T10/04-195r3 SAS-1.1 Internal Wide Connector/Cable Electrical Requirements

To: T10 Technical Committee  
 From: Barry Olawsky, HP (barry.olawsky@hp.com)  
 Date: 24 August 2004  
 Subject: T10/04-195r3 SAS-1.1 Internal Wide Connector/Cable Electrical Requirements

**Table — Internal 4-lane Cable/Connector Solution Electrical Requirements**

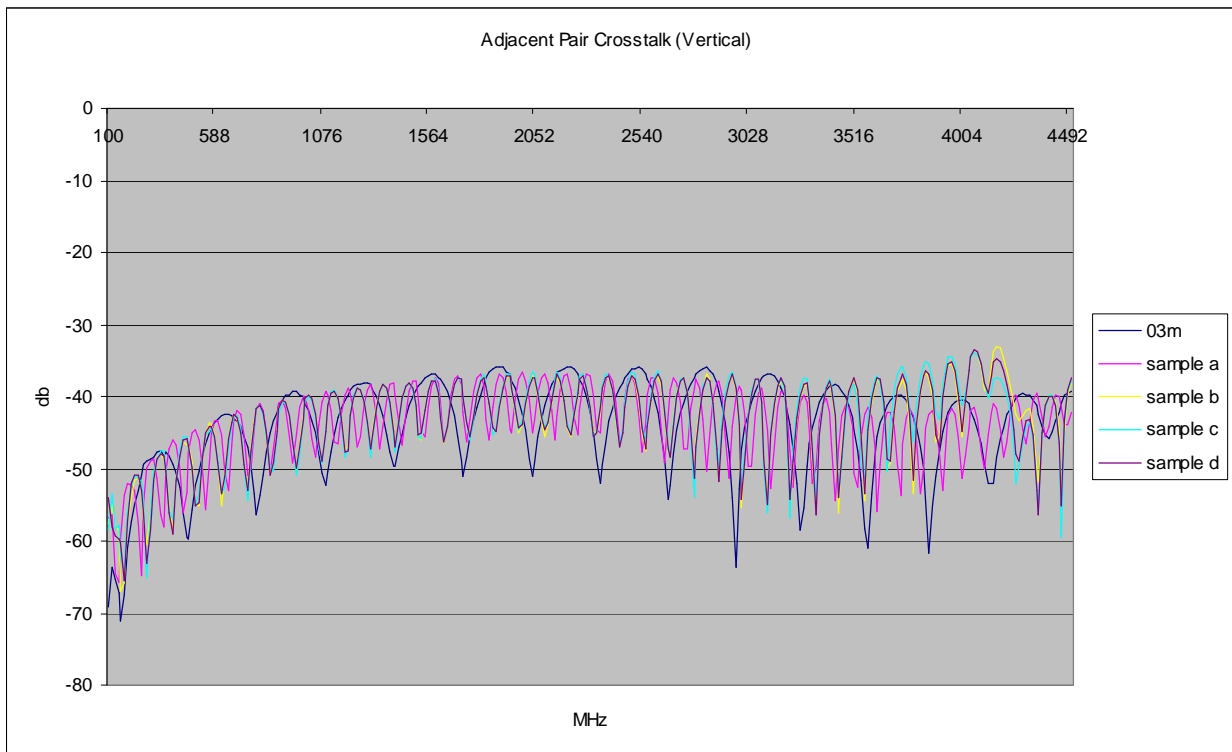
Requirement	Units	1,5 Gbps	3,0 Gbps
<del>Equivalent</del> Time domain reflectometer rise time 20 % to 80 % <sup>a, b</sup>	ps	70 <u>(max)</u>	70 <u>(max)</u>
<b>Media (PCB or cable)</b>			
Differential impedance <sup>b, c, d</sup>	ohm	100 ± 10	100 ± 10
Differential impedance imbalance <sup>b, c, d, e</sup>	ohm	5	5
Common mode impedance <sup>b, c, d</sup>	ohm	32,5 ± 7,5	32,5 ± 7,5
<b>Mated connectors</b>			
Differential impedance <sup>b, c, d</sup>	ohm	100 ± 15	100 ± 15
<b>Mated Cable Assembly</b>			
Maximum Insertion Loss <sup>b, f</sup>	db	6	6
Maximum Near-End Crosstalk (adjacent pairs) <sup>b, f, g</sup>	db	33	33
Maximum Near-End Crosstalk (between pairs differential signal pairs 1, 2, 3 and 4) <sup>b, f, g</sup>	db	45	45
Maximum Near-End Crosstalk (between differential signal pairs 5, 6, 7 and 8) <sup>b, f, g</sup>	db	45	45
Maximum Near-End Crosstalk (all other differential signal pair combinations) <sup>b, f, g</sup>	db	50	50

Maximum Intra-Pair Skew <sup>b</sup>	ps	10	10
<sup>a</sup> <del>All times indicated for time domain reflectometer measurements are recorded times. Recorded times</del>

~~are twice the transit time of the time domain reflectometer signal.~~ Filtering may be used to obtain the equivalent rise time. The filter consists of the two-way launch/return path of the test fixturing, two-way launch/return path of the test cable and the software or hardware filtering of the TDR scope. The equivalent rise time is the rise time of the TDR output after application of all filter components. Filtering effects of test cables and fixturing shall be considered when configuring instrumentation to obtain the equivalent rise time.

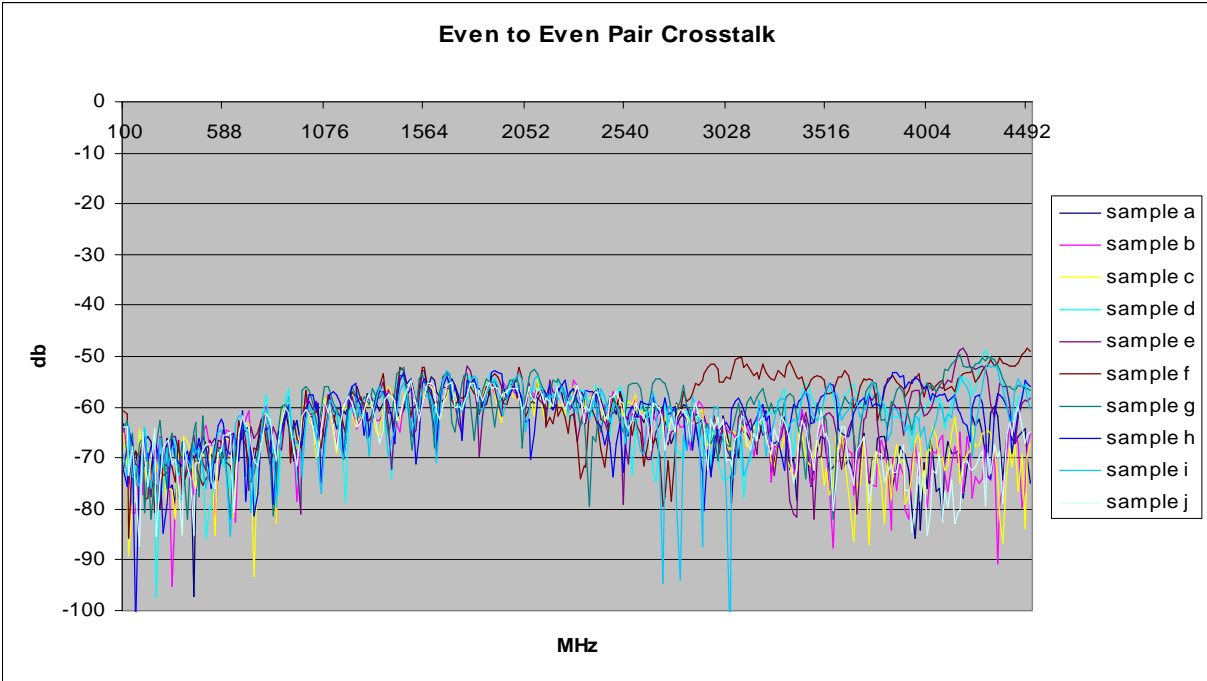
Various cable samples from different suppliers were randomly selected and the tests performed with various differential signal pairs. Plots with higher crosstalk peaks are combined to understand how existing product compares to the proposed crosstalk levels. The following data is clearly NOT a statistical sample of product available.

Adjacent pairs are RX0/TX0, TX0/RX1, RX1/TX1, RX2/TX2, TX2/RX3, RX3/TX3.
